Title - Sujet Réfection du toit-Terrasse - OACI	
Solicitation No. - N° de l'invitation EE520-192457/A	Amendment No. - N° modif. 006
Client Reference No. - N° de référence du client EE520-192457	Date 2019-02-27
GETS Reference No. - N° de référence de SEAG PW-\$MTC-110-15197	
File No. - N° de dossier MTC-8-41345 (110)	CCC No./N° CCC - FMS No./N° VME
Solicitation Closes - L'invitation prend fin at - à 02:00 PM on - le 2019-03-04	
Time Zone Fuseau horaire Heure Normale du l'Est HNE	
F.O.B. - F.A.B. Plant-Usine: <input type="checkbox"/> Destination: <input checked="" type="checkbox"/> Other-Autre: <input type="checkbox"/>	
Address Enquiries to: - Adresser toutes questions à: Hivon, Michèle	Buyer Id - Id de l'acheteur mtc110
Telephone No. - N° de téléphone (514) 607-4952 ()	FAX No. - N° de FAX (514) 496-3822
Destination - of Goods, Services, and Construction: Destination - des biens, services et construction:

Roof Terrace Renovation – ICAO Headquarters

AMENDMENT 006

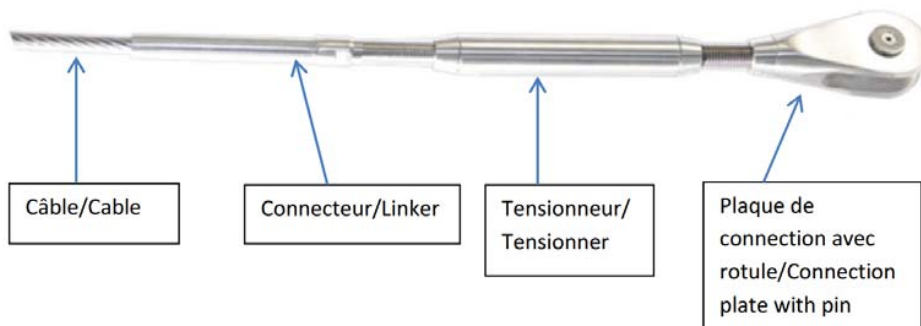
Our sub-trade requires more information regarding the horizontal bracing in stainless steel shown on the structural drawings.

There exist too many options to provide a specific budget.

Please clarify the types of components required.

The requirement is to provide as system with the properties on plan (resistance, diameter, material and prefabricated connections). Other factor such as the position of the tensioner is not a criterion.

Please see attached sketch of the system as an example. We are not allowed to indicate a specific provider.

ANNEXE/ANNEX 1

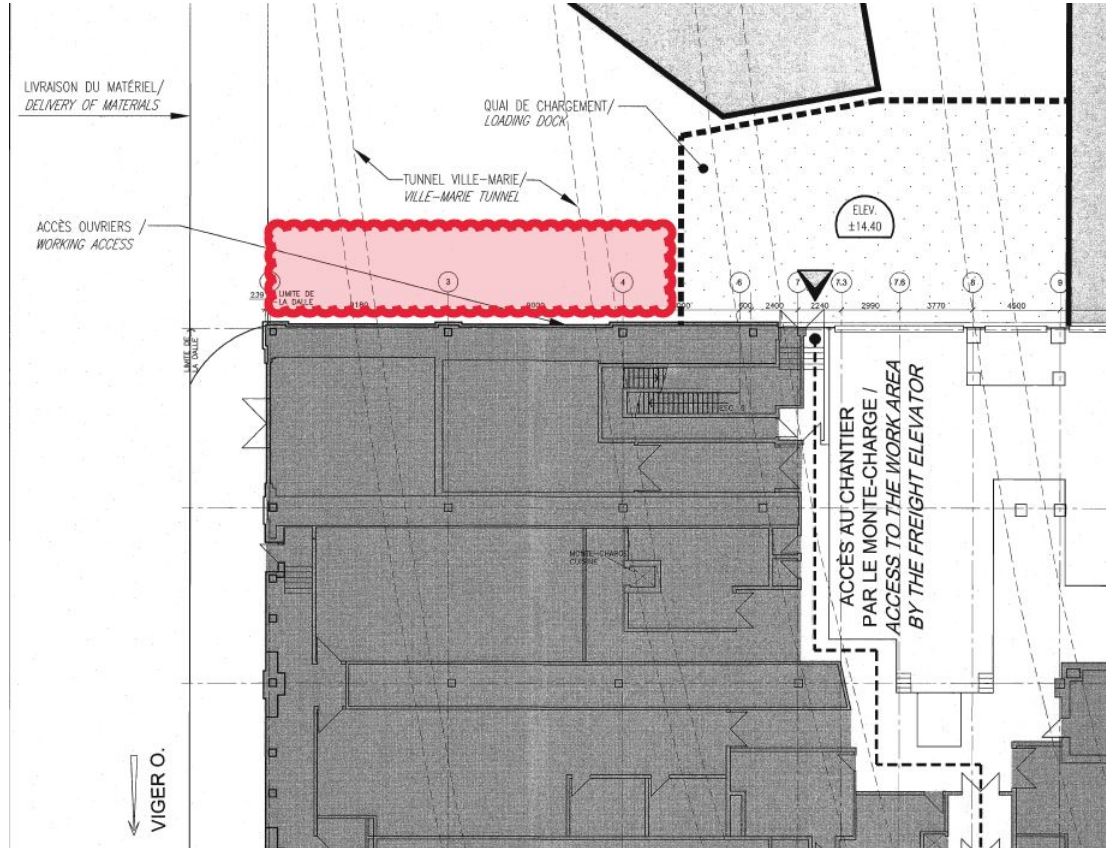
Also, will our container have to be moved every day given the limited space?

It will be possible, for the selected contractor, to use the area identified in the annexed document, to install a container for an extended period. The presence of the container must not interfere with traffic. You will need to coordinate the exact positioning and duration of the installation with the Departmental Representative
